HISTORIC LANDMARK COMMISSION
PERMITS IN NATIONAL REGISTER HISTORIC DISTRICTS
SEPTEMBER 7, 2022
HR-2022-112041
TRAVIS HEIGHTS- FAIRVIEW PARK
2110 KENWOOD

New construction of an ADU and demolition of a carport.

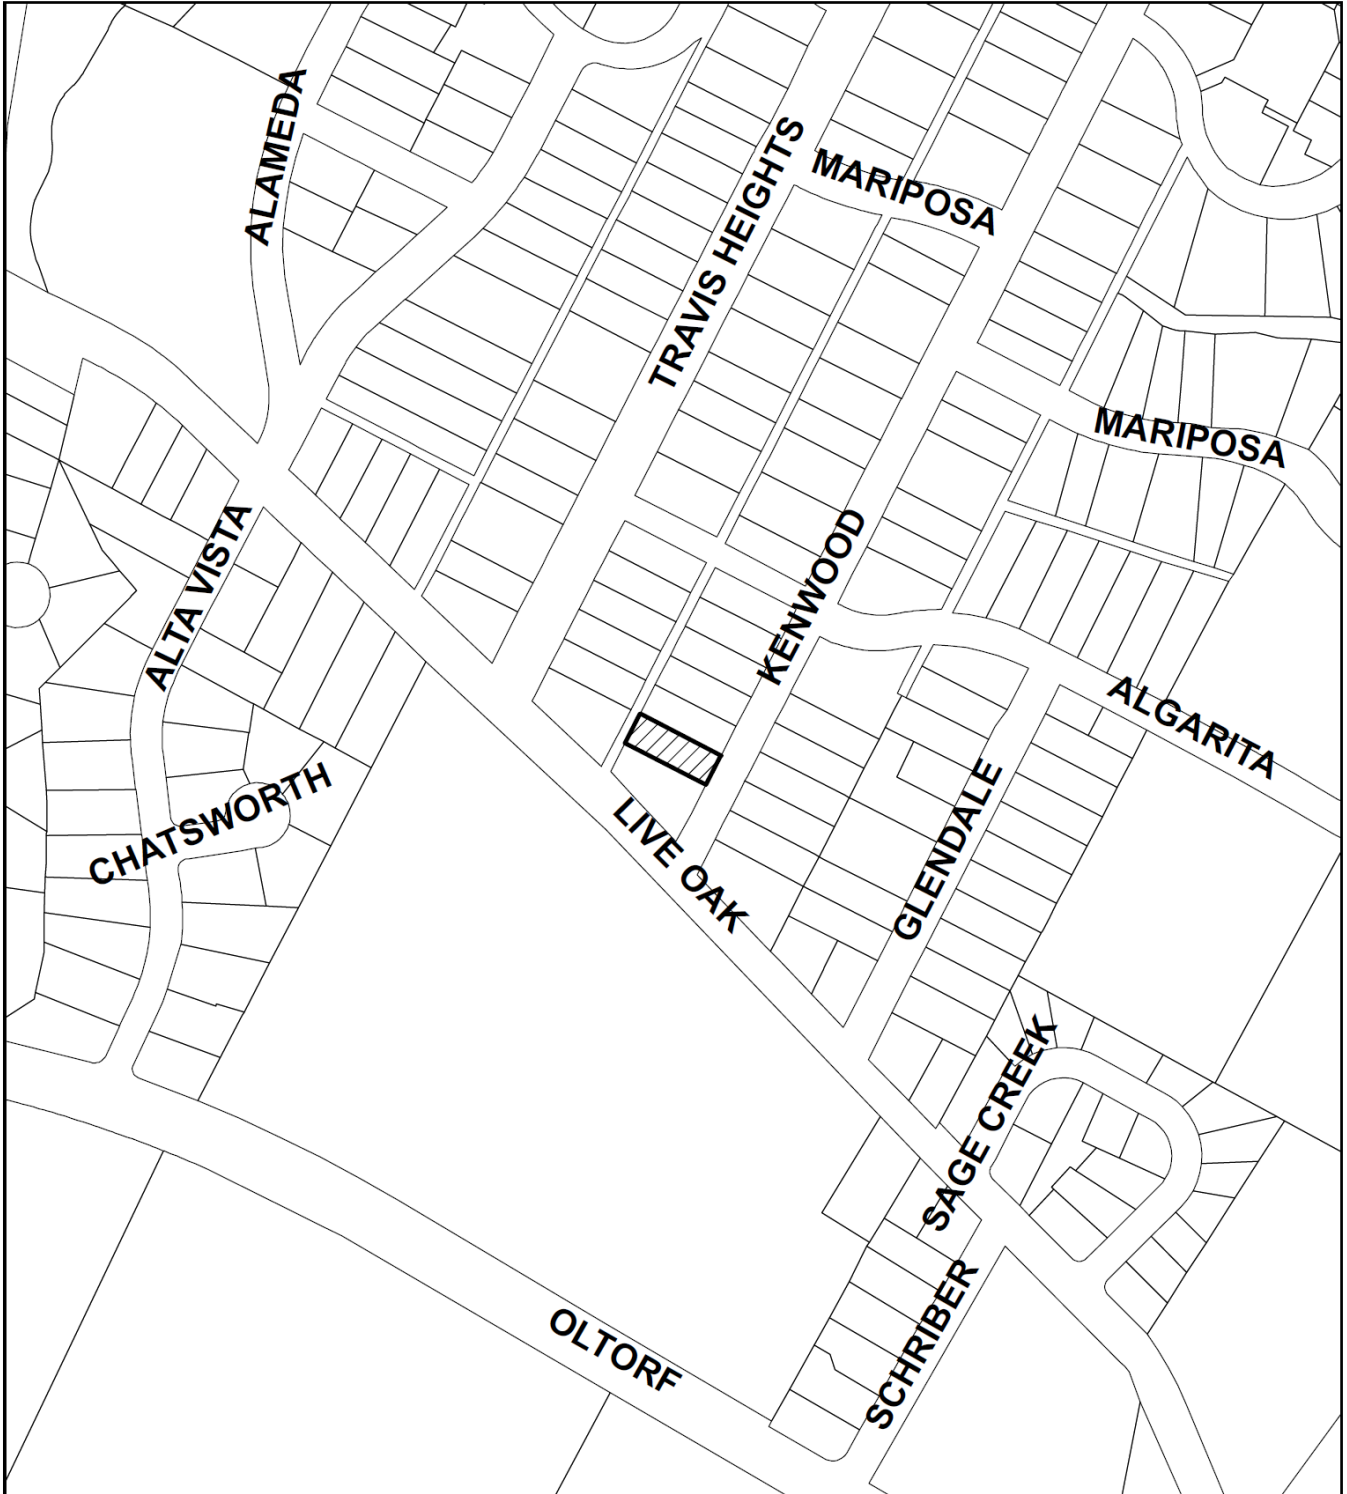
The windows on the East elevation do not appear to take cues from the Ranch style and could be improved upon by

referencing the primary structure's windows since they may be viewable from the street.

Approve the application as submitted with the comment that the window design of the ADU references the Ranch Style windows of the primary house where possible on the East elevation.
